TENNESSEE VALLEY AUTHORITY

BROWNS FERRY NUCLEAR PLANT  
UNIT 2, CYCLE 6

RELOAD LICENSING REPORT

PROPOSED  
TECHNICAL SPECIFICATION CHANGES

Figure 14  
OLMCPR for P8X8R/8X8R/QUAD+

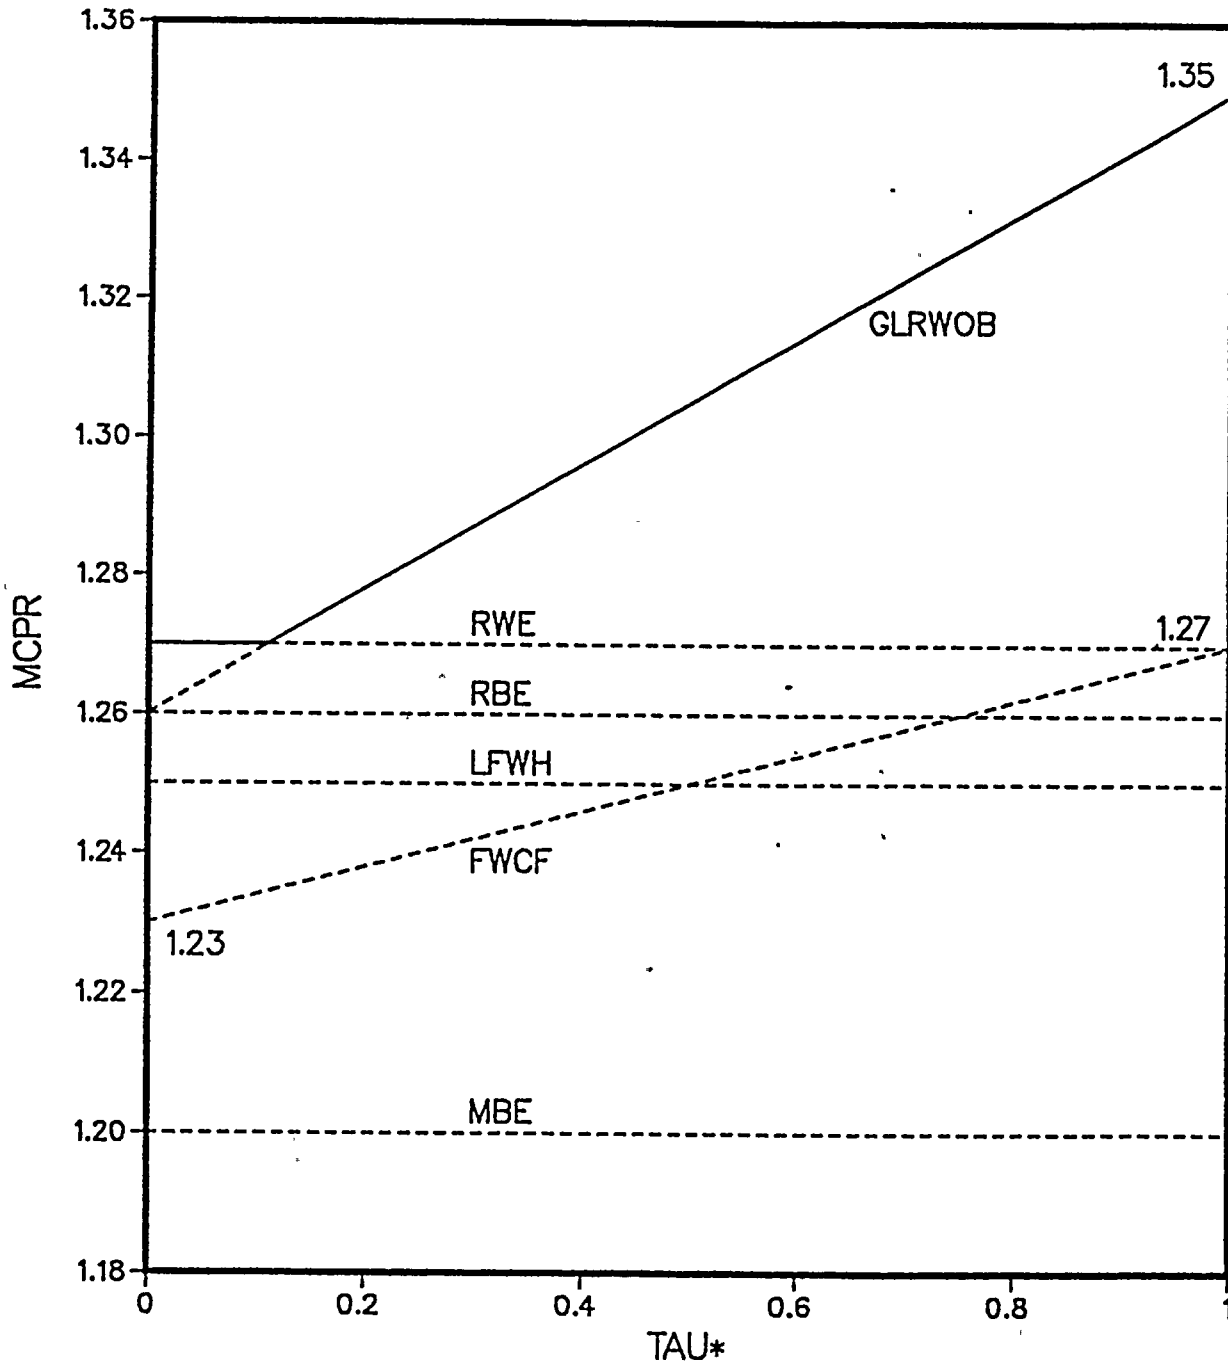
Figure 3.5.K-1 MCPR vs TAU is changed because of the reanalysis. The reanalysis indicated the bounding accidents are rod withdrawal error and generator load reject without bypass. All of the accidents and the bounding envelope are shown in figure 14 of the Reload Licensing Report.

Figure 3.5.K-1  
 MCPR Limits for P8 X 8R/8 X 8R/ QUAD+

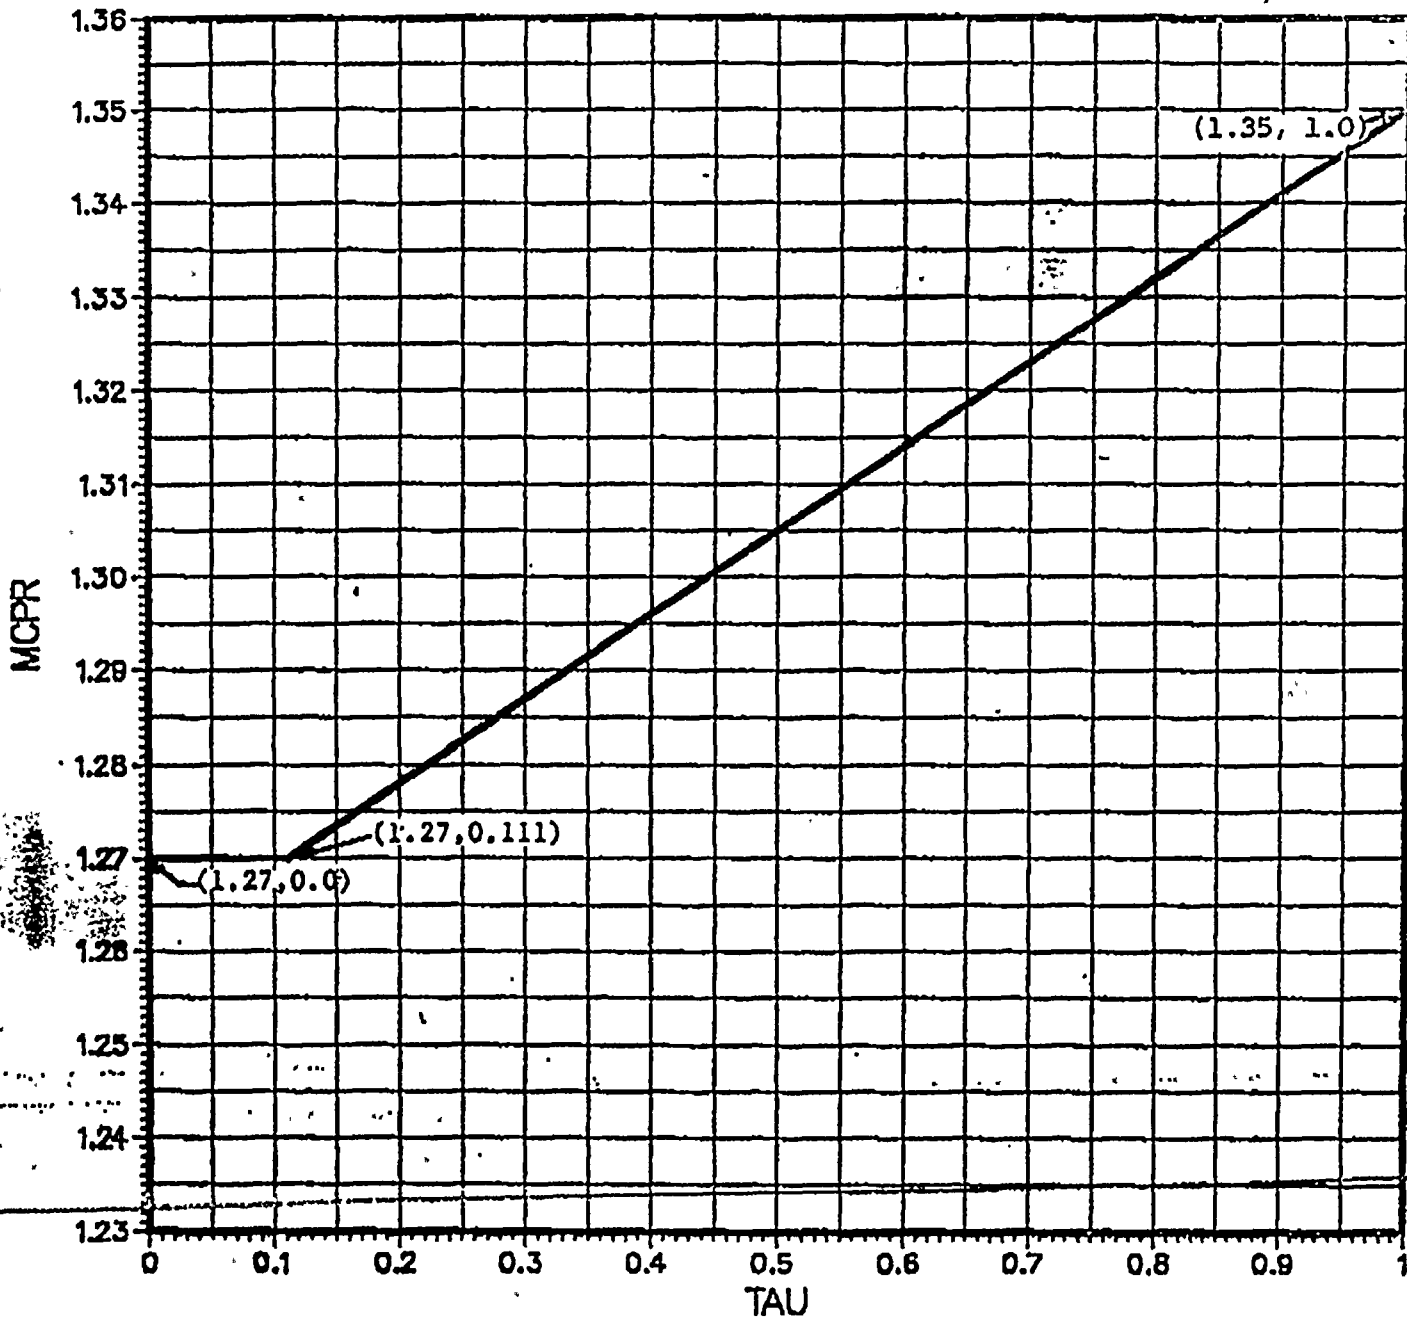
The Minimum Critical Power Ratio as a function of scram time (figure 3.5.K-1) has changed because of the reanalysis performed to include BFN Unit 1 fuel in the Unit 2 reload.
